02 June 2026
Our Ref: 25/8814/L01

RE: PLANNING APPLICATION: 4776/APP/2026/970 - LAND AT 151 STATION ROAD WEST DRAYTON

RESPONSE TO COMMENTS ON HIGHWAYS

Drawing Title: **Proposed Access & Visibility Splays**

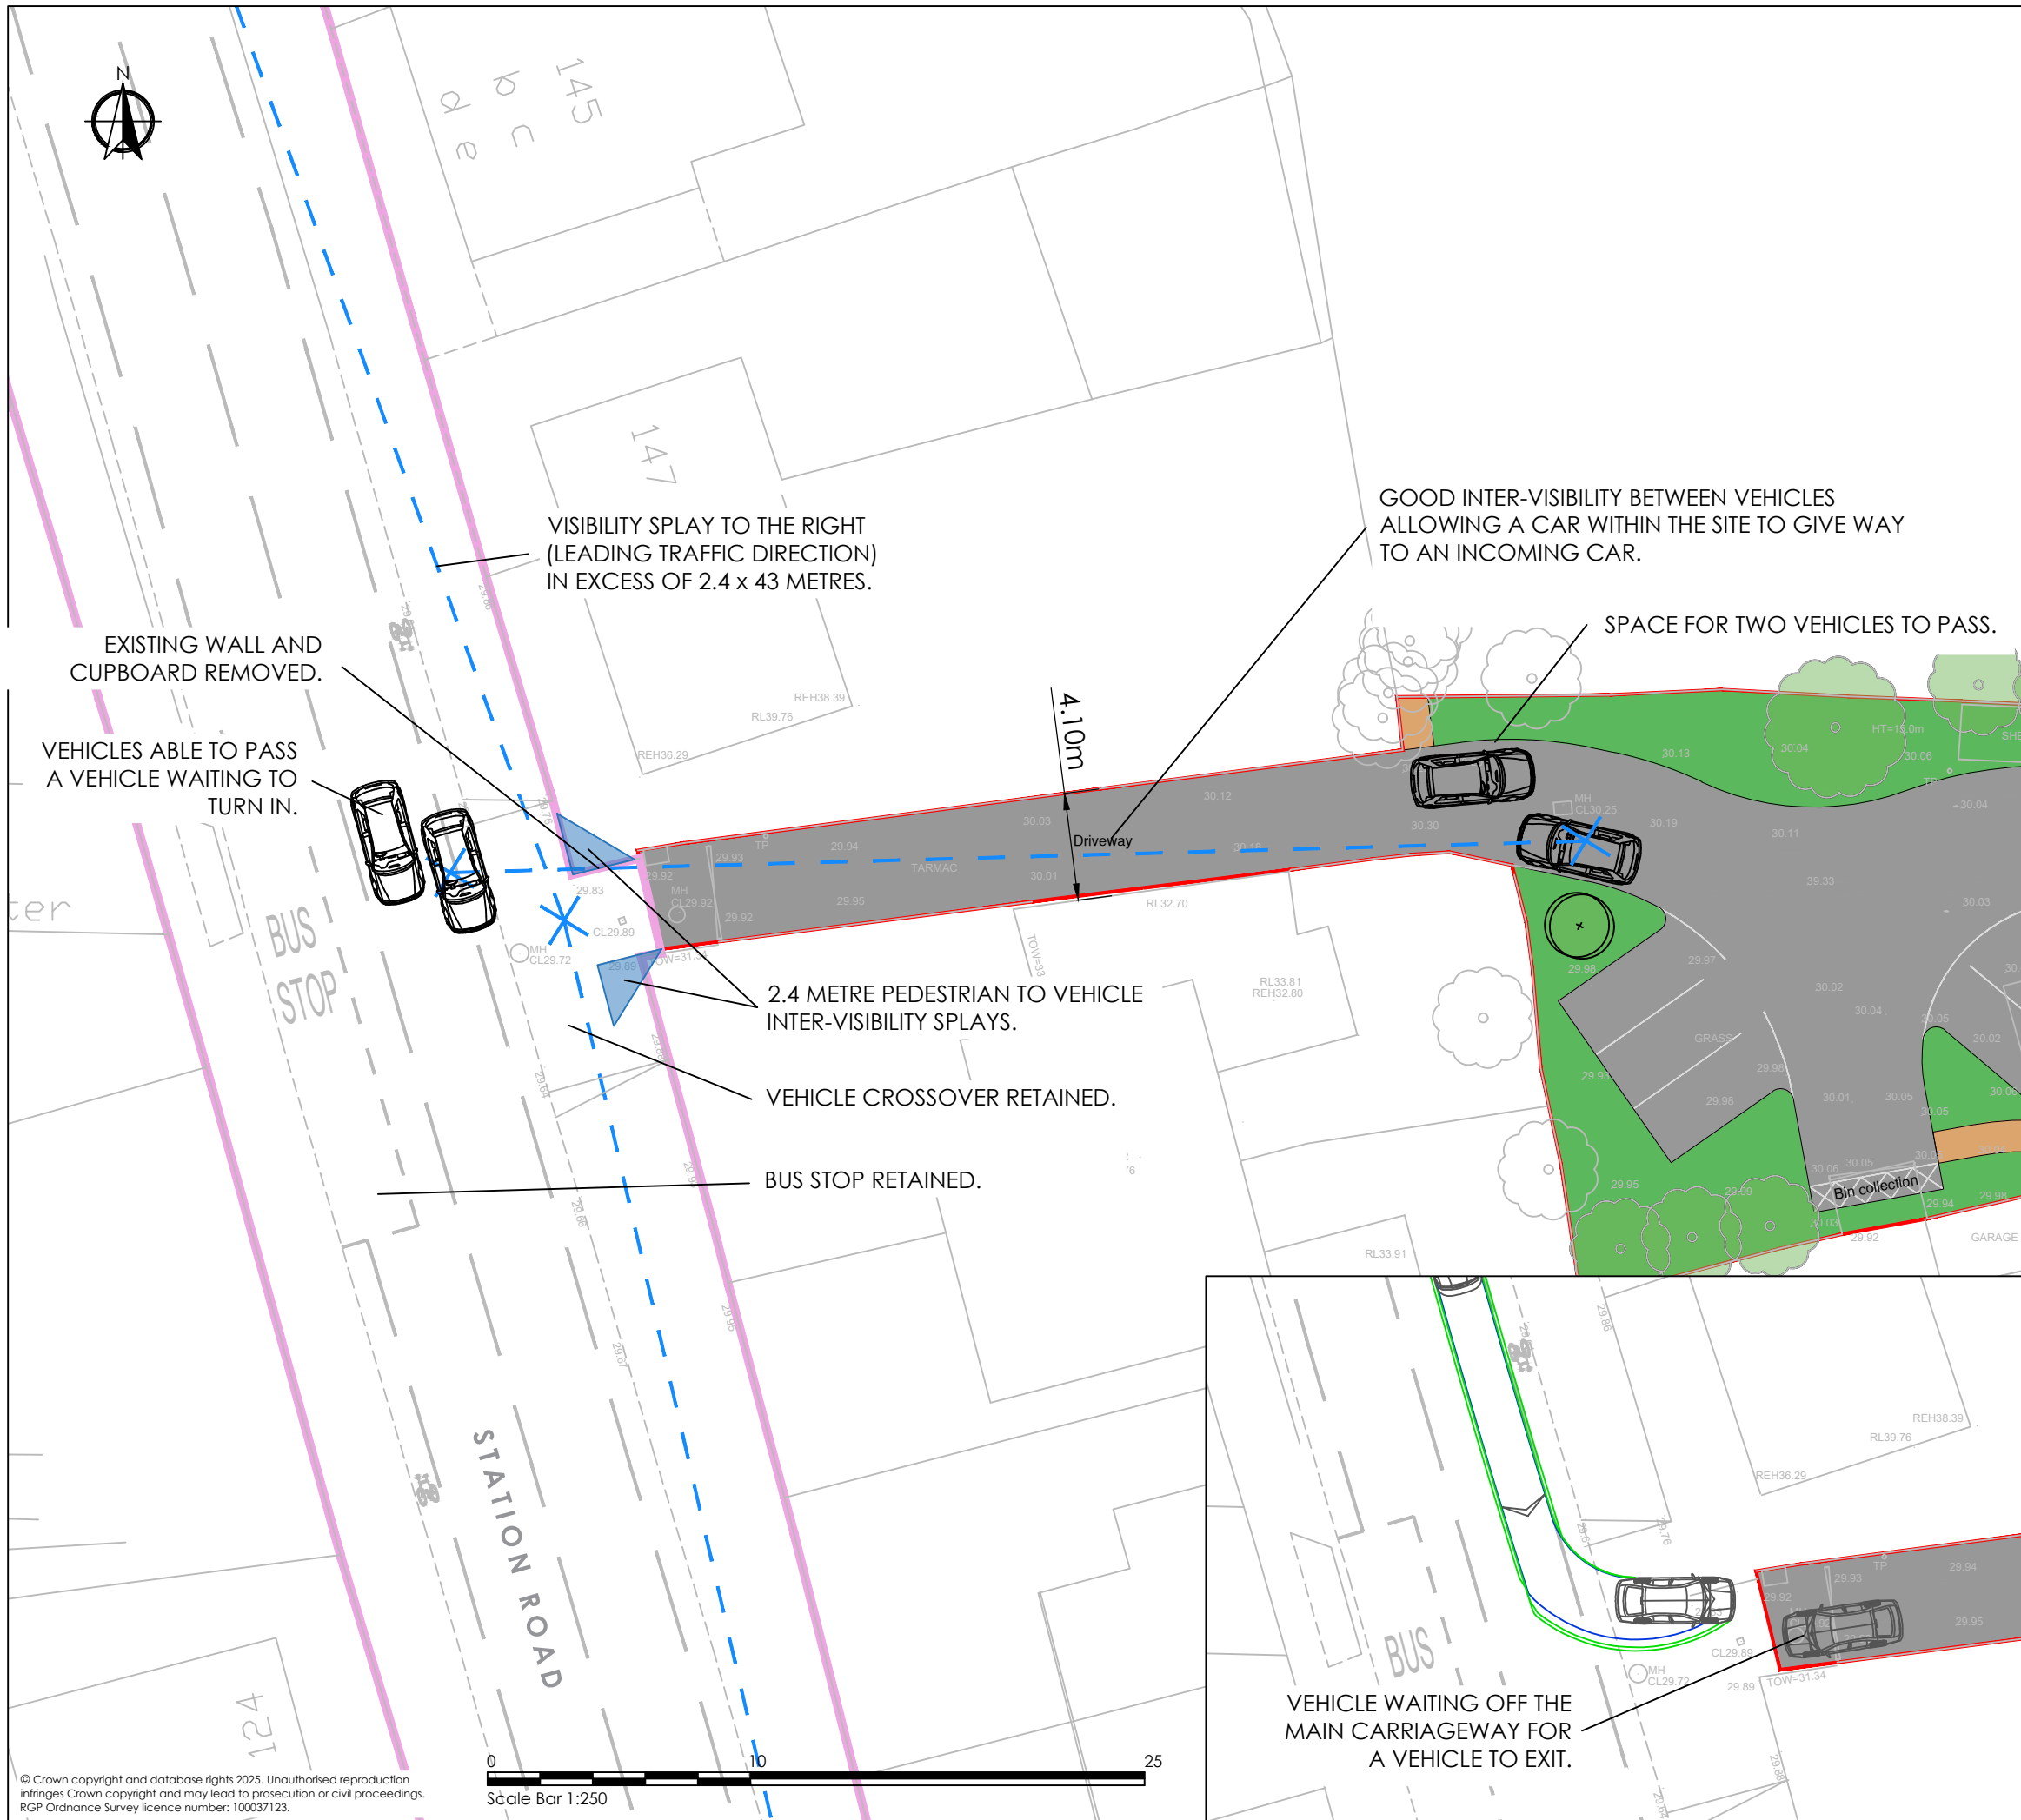
Due to the substandard width and absence of passing places, vehicles will inevitably be required to reverse along the access to allow opposing movements. This concern is not simply related to overall trip generation, but to the inherent operation of the access itself. In particular, where a vehicle turns into the access from Station Road without awareness of a vehicle already committed within it, that vehicle would be forced to stop and reverse, potentially over a considerable distance. These reversing manoeuvres are likely to exceed 20 metres, which is contrary to established highway design principles that seek to minimise reversing distances, particularly within constrained and shared environments, due to the increased risk of collision and reduced predictability of movements.

Even where drivers are aware of an oncoming vehicle prior to entering, this would result in vehicles waiting at or close to the site entrance. Such waiting would obstruct the free flow of traffic on Station Road and create additional pressure on the highway network. This is particularly problematic given the presence of a cycle lane and a bus stop directly opposite the access. Stationary buses already constrain available carriageway space, and in such circumstances, following vehicles may attempt to overtake into the opposing lane, while another vehicle is stationary or manoeuvring at the access. This effectively reduces the usable carriageway on both sides and creates a highly constrained environment with multiple competing movements.

The proposal fails to provide adequate pedestrian safety measures at the site access. In particular, no pedestrian visibility splays of 2.4m x 2.4m are provided at the back edge of the footway. These splays, with no obstruction above 0.6m in height, are a fundamental requirement to ensure that drivers exiting the site and pedestrians using the footway can see one another clearly. Given the intensification of use of the access road the absence of these splays results in a constrained and obscured interface between the private access and the public highway, significantly increasing the risk of conflict between vehicles and pedestrians.

Furthermore, the access operates as a shared surface with no delineation or segregation between pedestrians and vehicles. In low-speed, well-designed environments this may be acceptable; however, in this instance the combination of restricted width, lack of inter-visibility, and the need for reversing movements creates an environment where vulnerable users are exposed to increased risk. The intensification of the site use will result in a greater number of pedestrian and vehicular movements using this constrained access, exacerbating these safety concerns.

As above, this occurrence would be incredibly infrequent and, if it were to occur, for a matter of seconds. Notwithstanding, the southbound lane on Station Road is 4.1m width which would allow vehicles to pass whilst another waits. This is shown on drawing **STA-RGP-XX-XX-DR-T-001**. As above, in addition, a vehicle could also stop within the existing vehicle crossover extents for another vehicle to exit. Therefore, in practice vehicles would not have to wait and would not need to use the opposing lane. As stated, this practice is used by many accesses along Station Road.

The pedestrian inter-visibility zones are shown on drawing **STA-RGP-XX-XX-DR-T-001**. These splays are as existing, with drivers exiting able to observe pedestrians in the correct way. As confirmed in Hillingdon's vehicle crossover guidance:

In this instance, a driver would observe pedestrians across the adjoining land on either side, both of which are points of access that would be retained as open and available for visibility (in the same way that the adjoining properties look across the site access to observe pedestrians).

The access is wide enough for a pedestrian and a car to pass one another. Drawing **STA-RGP-XX-XX-DR-T-001** shows clear inter-visibility along the access, allowing a vehicle to observe a pedestrian/cyclists along the carriageway. Signage can be provided to indicate the presence of a shared surface, details of which can be secured by planning condition.
